CALL NO. 206  
CONTRACT ID NO. 121354  
ADDENDUM # 2

Subject: Trigg-Marshall Counties, 121GR12D054-BRO  
Letting November 16, 2012

- (1) Revised - Plan Sheets - R1, R2A, R2B, R7, R8, R13, R14, R31, R32, R33, R35, R36, R38, R40, R41, R83, R85, X14, X15, X16, X18, X20, X21, & X26
- (2) Deleted - Plan Sheets - R25, R26, & R86 through R90
- (3) Revised - Front Page of Proposal
- (4) Revised - Completion Date - Page 4 of 177
- (5) Added - Dynamic Pile Testing - Pages 78(a)-78(c) of 177
- (6) Added - Static & Pseudo-Static Pile Testing - Page 96(a) of 177
- (7) Revised - Material Summary - Pages 130-132(a) of 177
- (8) Revised - Bid Items - Pages 173-175 of 177

BRO 0801 (093)  
RECONSTRUCT US 68 / KY 80  
GRADE & DRAIN PLANS

COUNTY OF	ITEM NO.	SHEET NO.
MARSHALL/ TRIGG	1-180.75	R2A

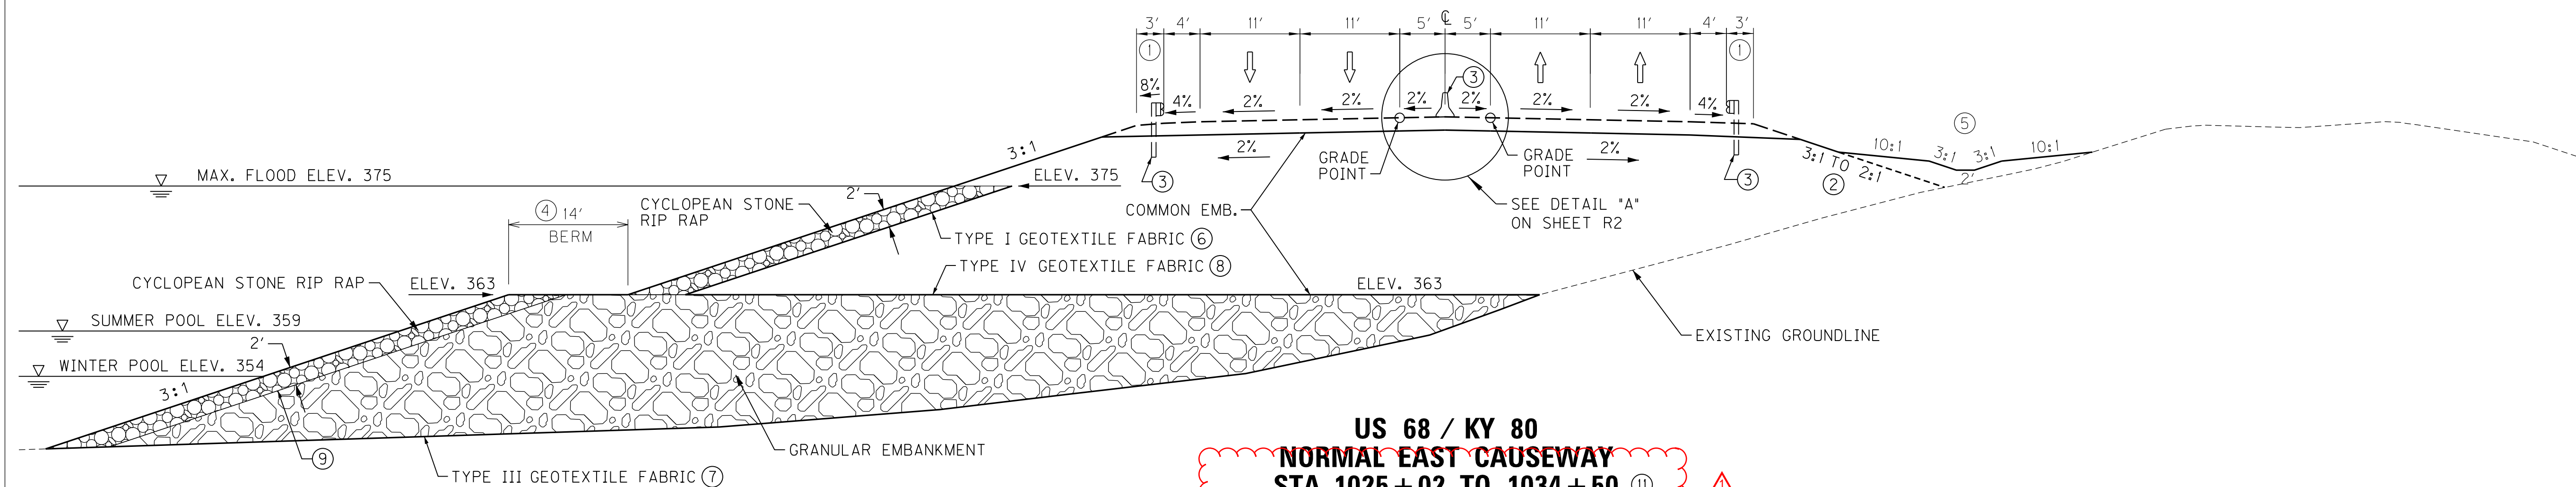
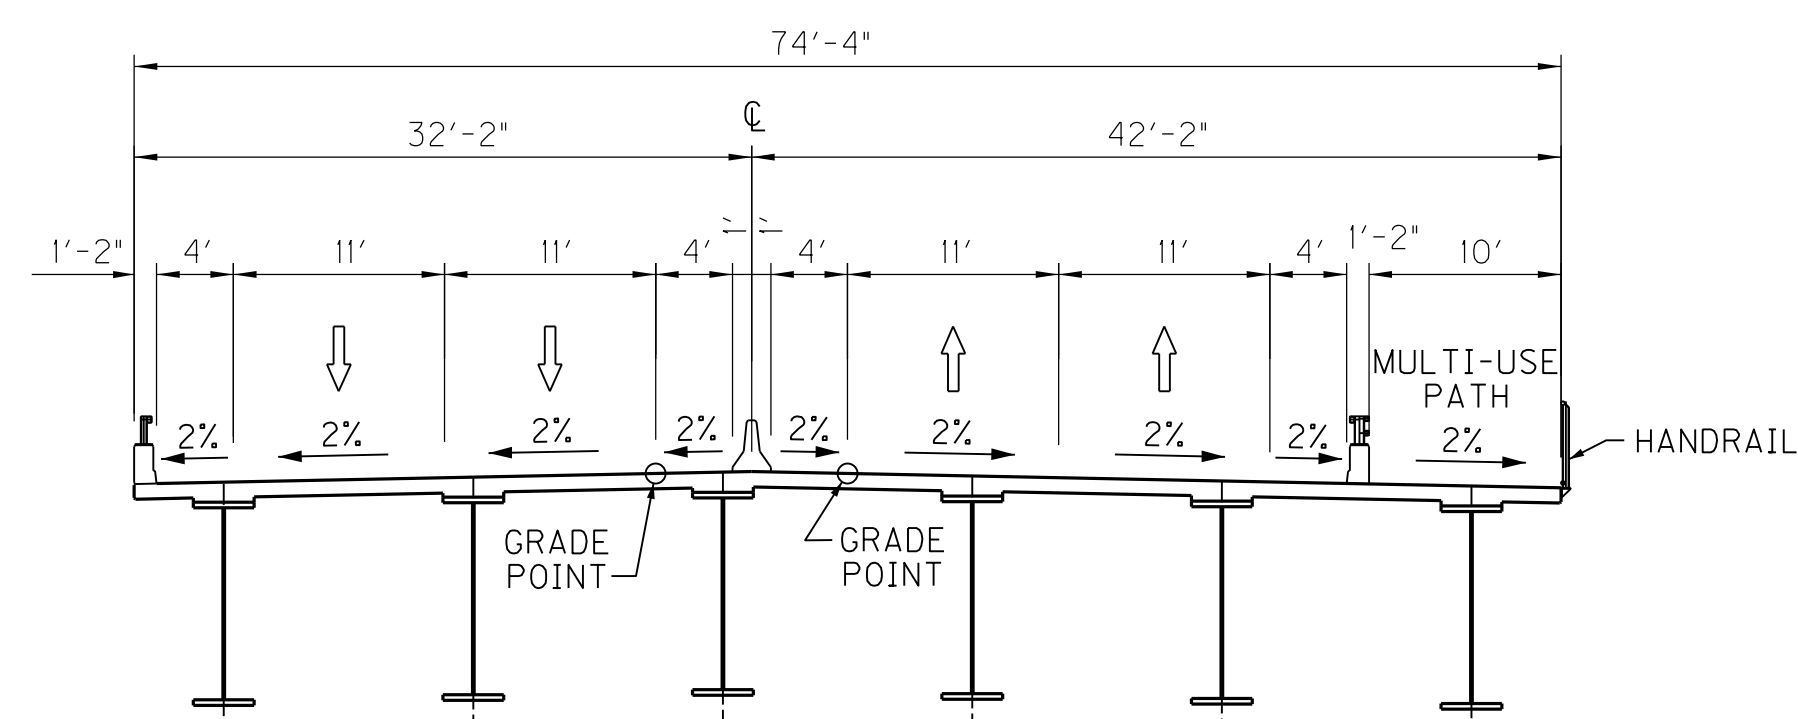
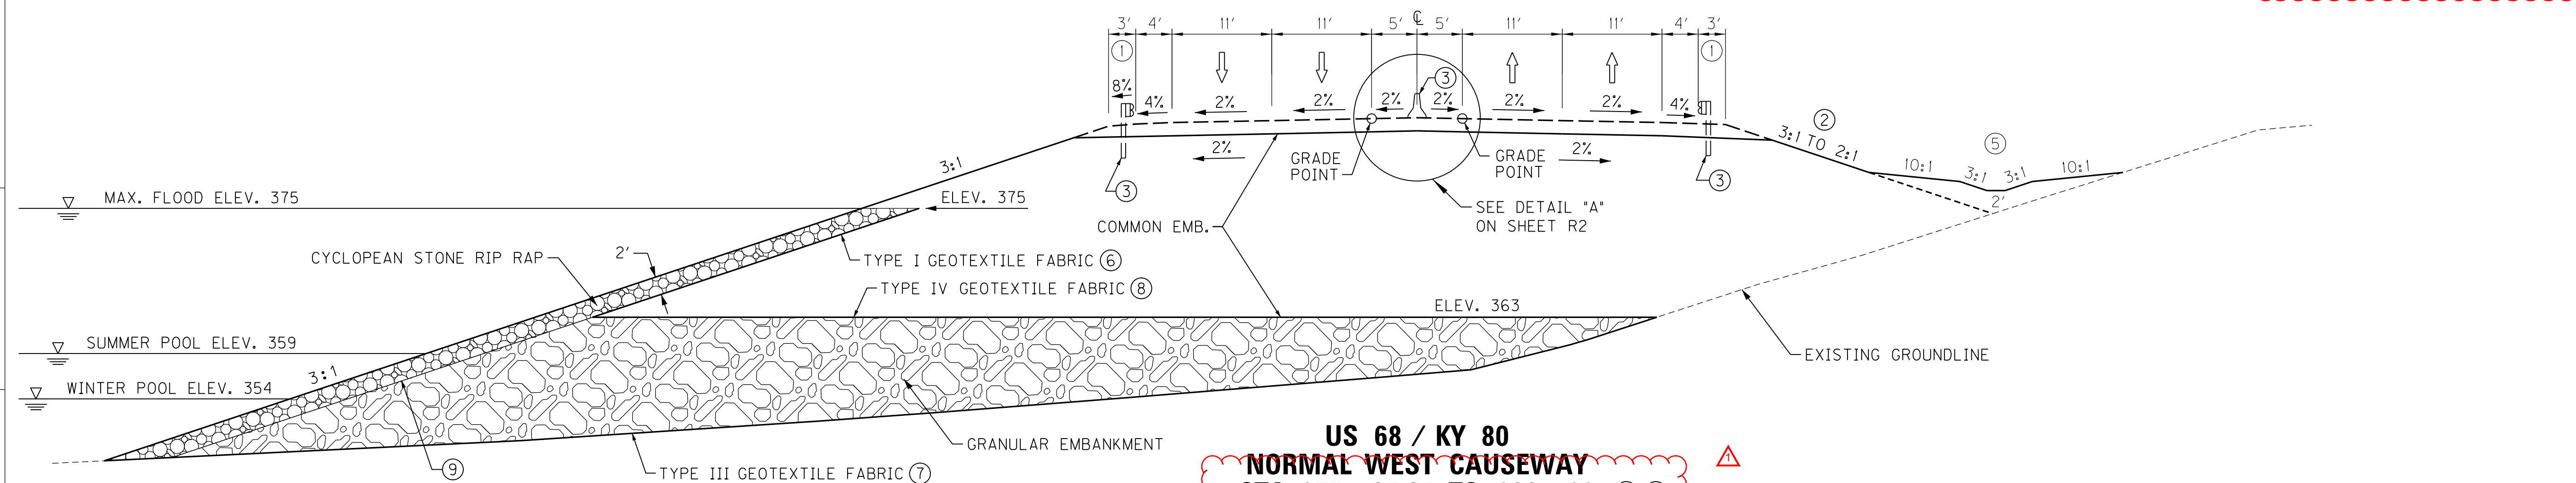
REVISD 10-31-12

- ⑨ TYPE I GEOTEXTILE FABRIC SHALL NOT BE PLACED BETWEEN THE GRANULAR EMBANKMENT AND THE CYCLOPEAN STONE RIP RAP, BELOW ELEV. 363.
  - ⑩ SEE STRUCTURE PLANS FOR APPROACH SLAB DETAILS - STA. 975+07.04 TO STA. 975+32.04

US 68/KY 80  
 STA. 978+00 TO STA. 993+00  
 PROFILE SHEET

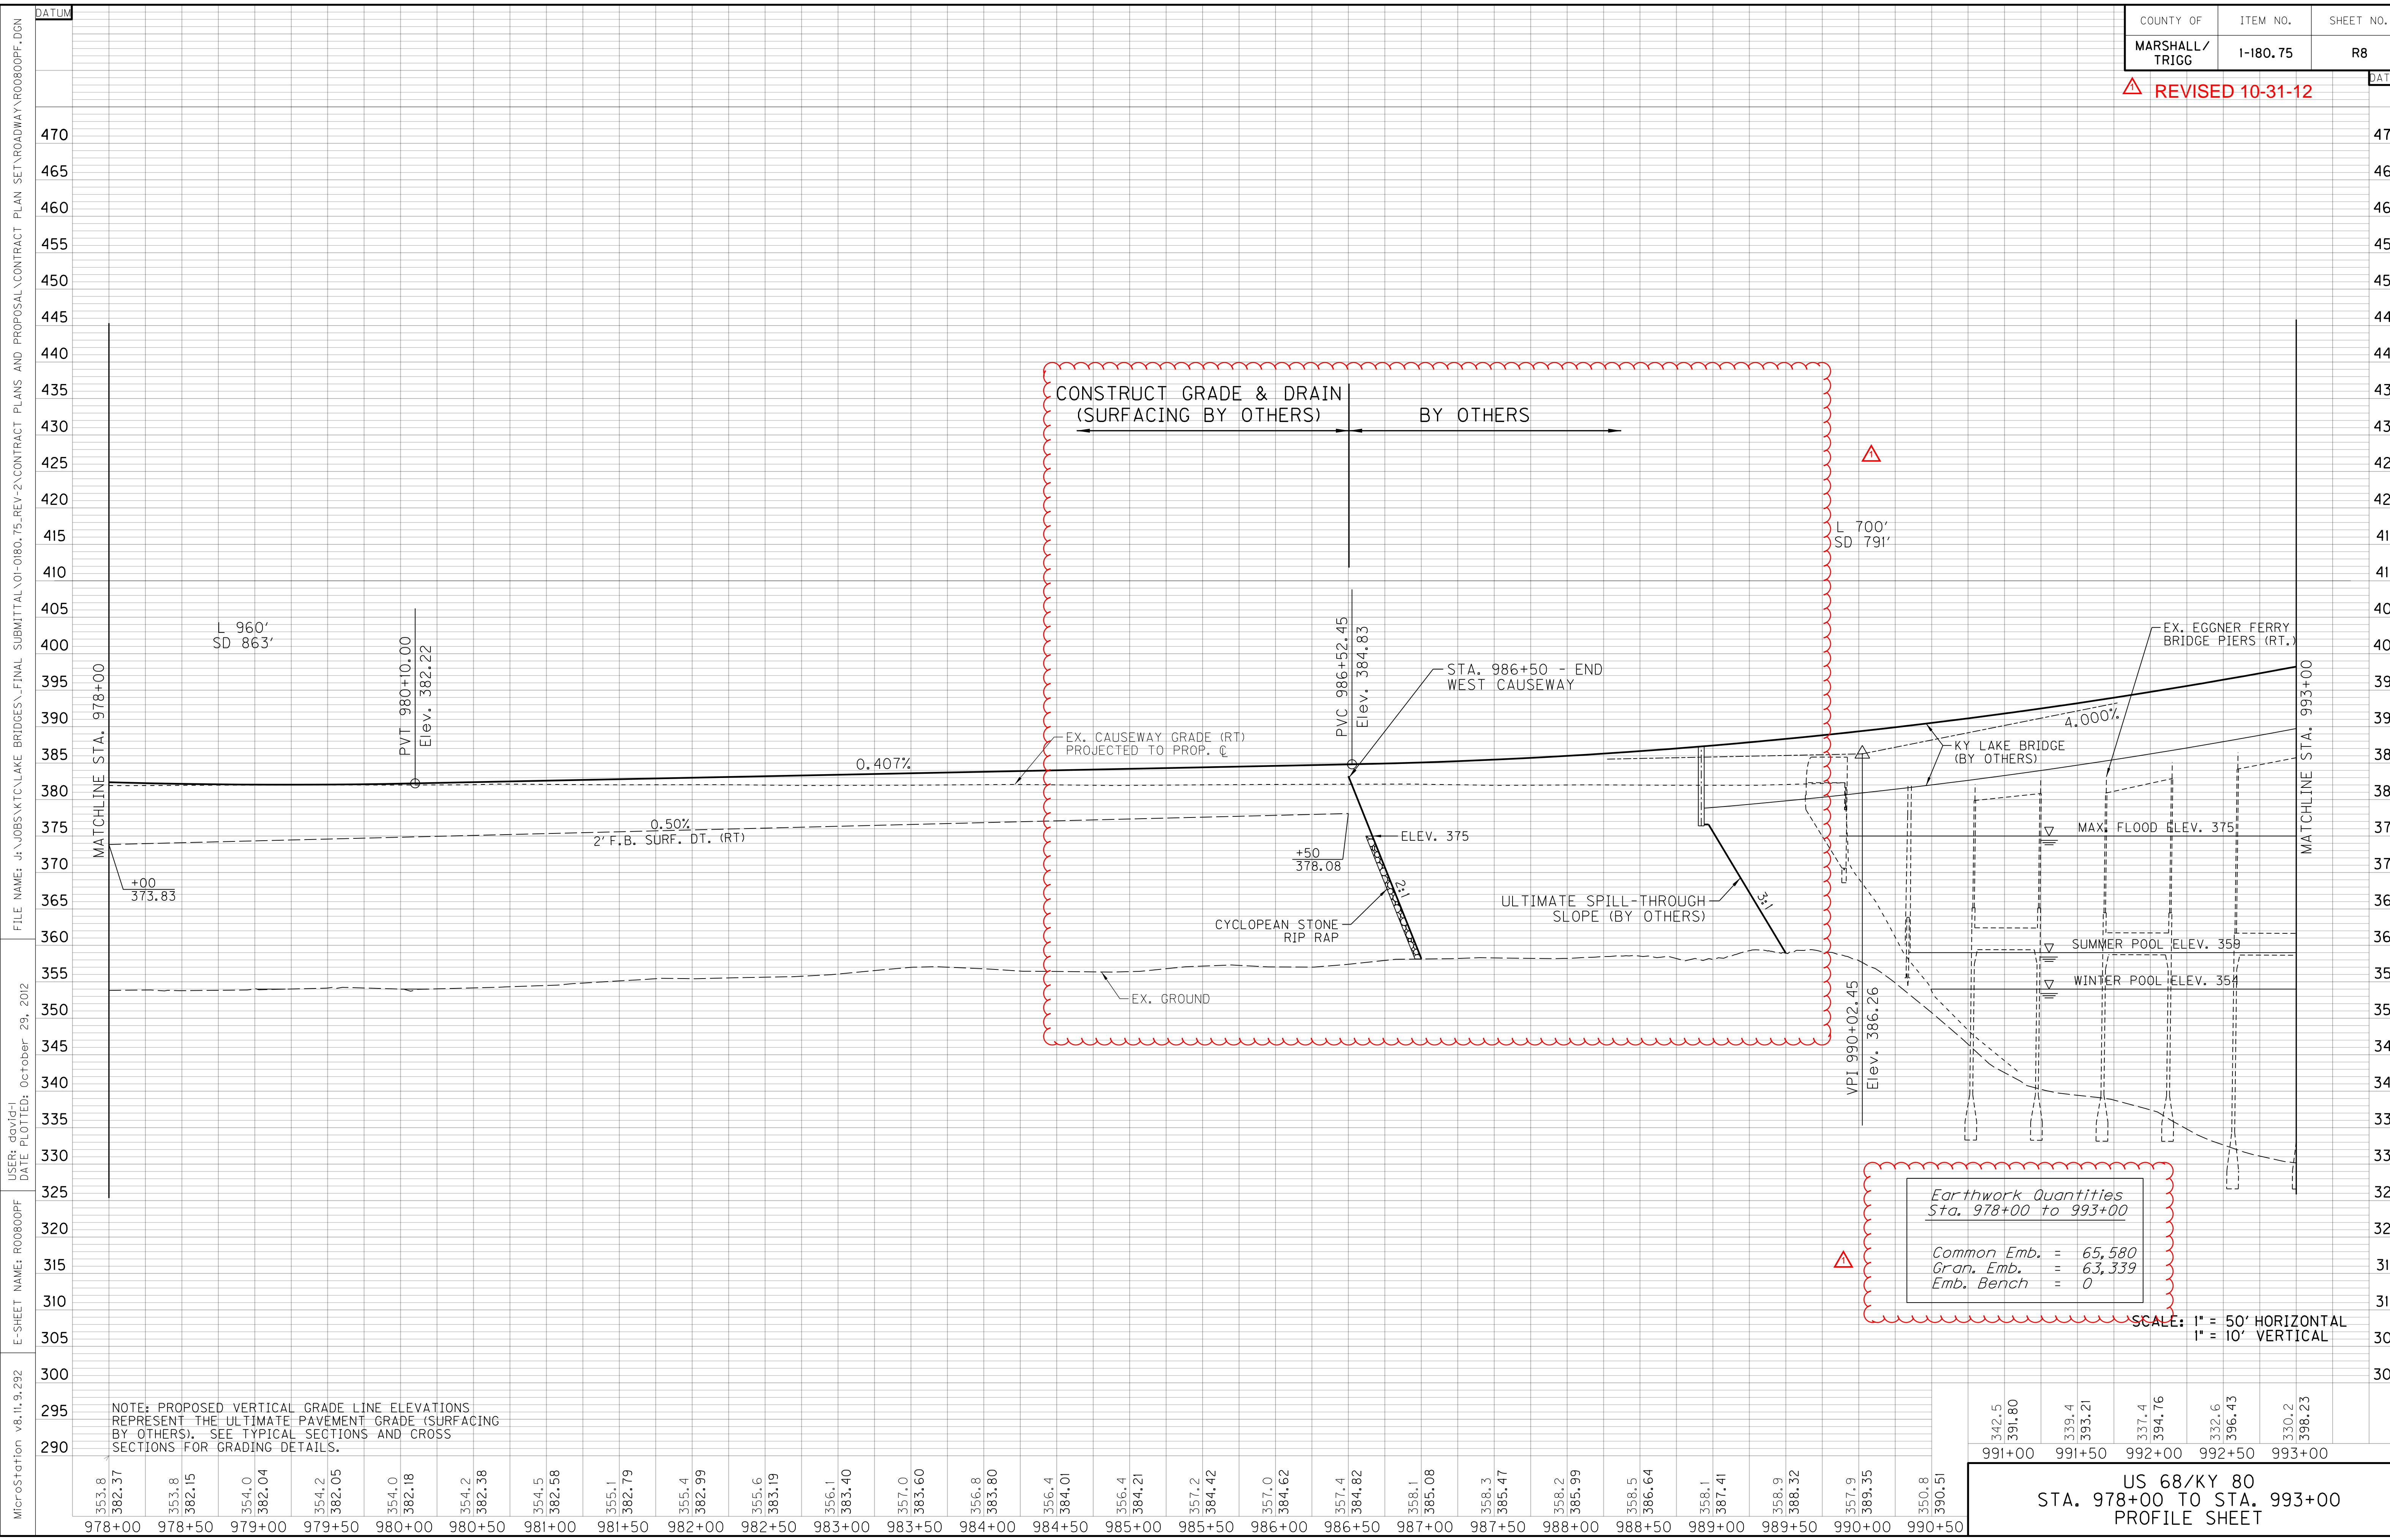
△ REVISED 10-31-12

US 68/KY 80  
STA. 1023+00 TO STA. 1038+00  
PROFILE SHEET

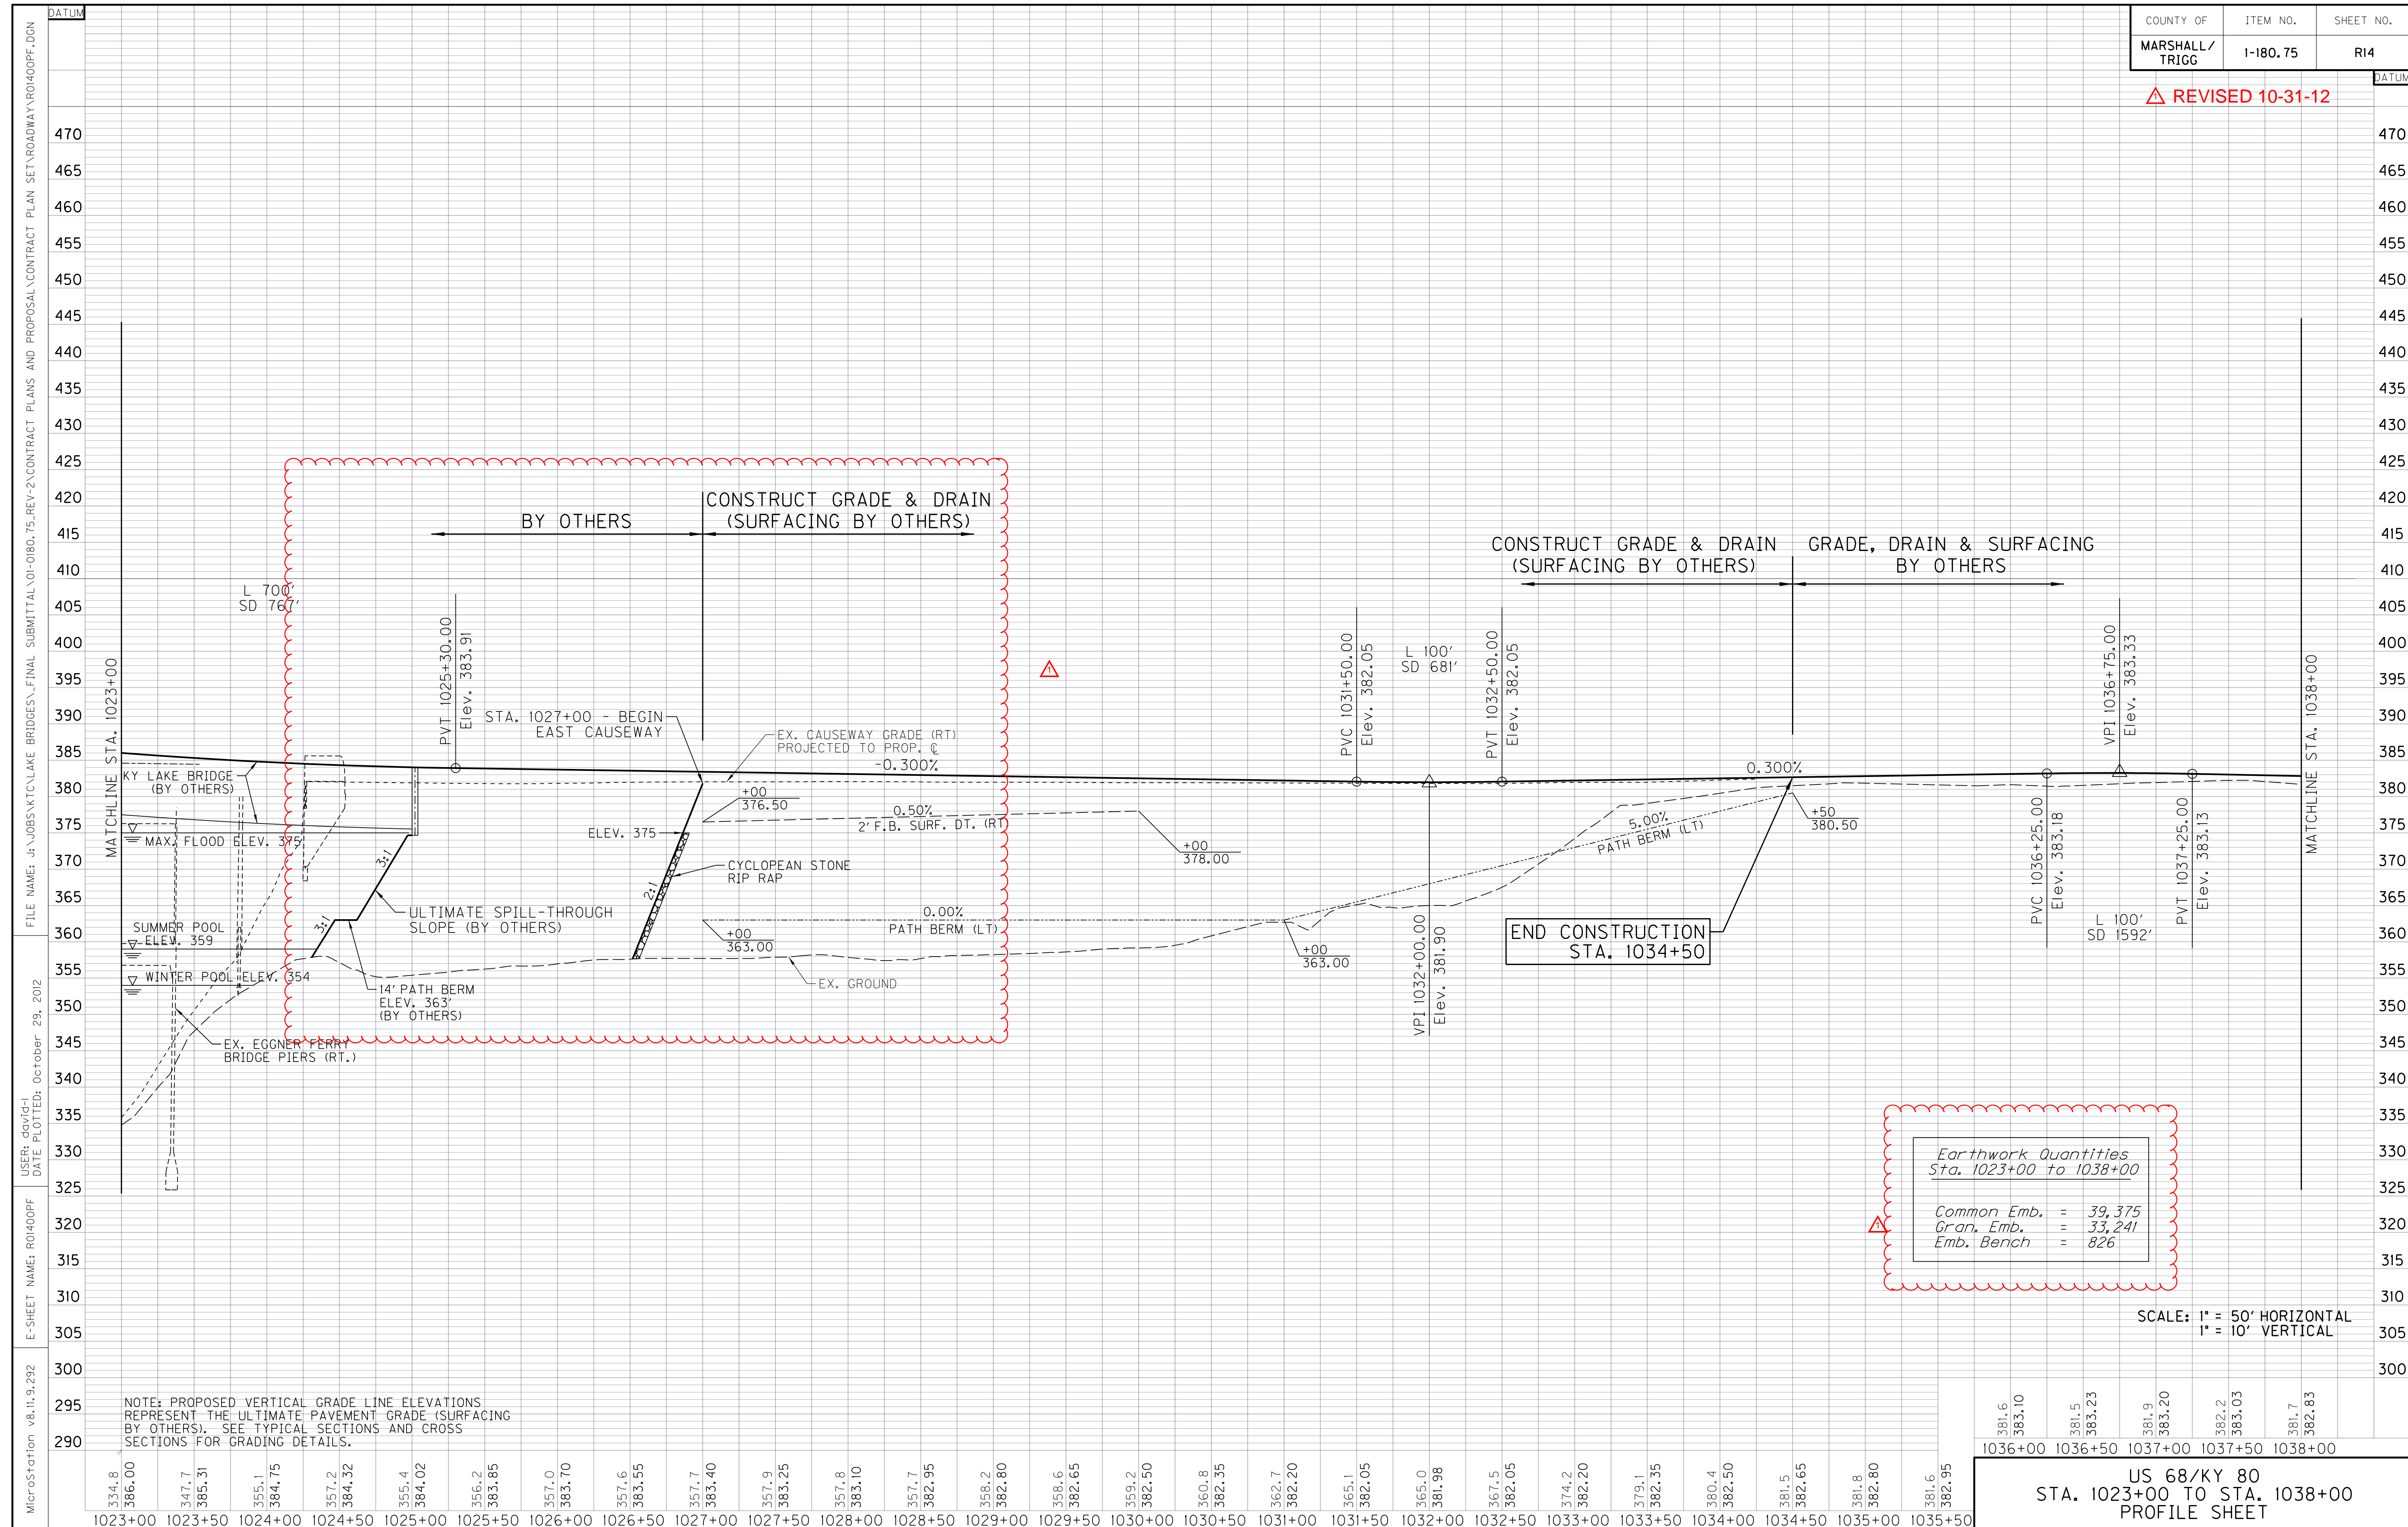
△ REVISED 10-31-12
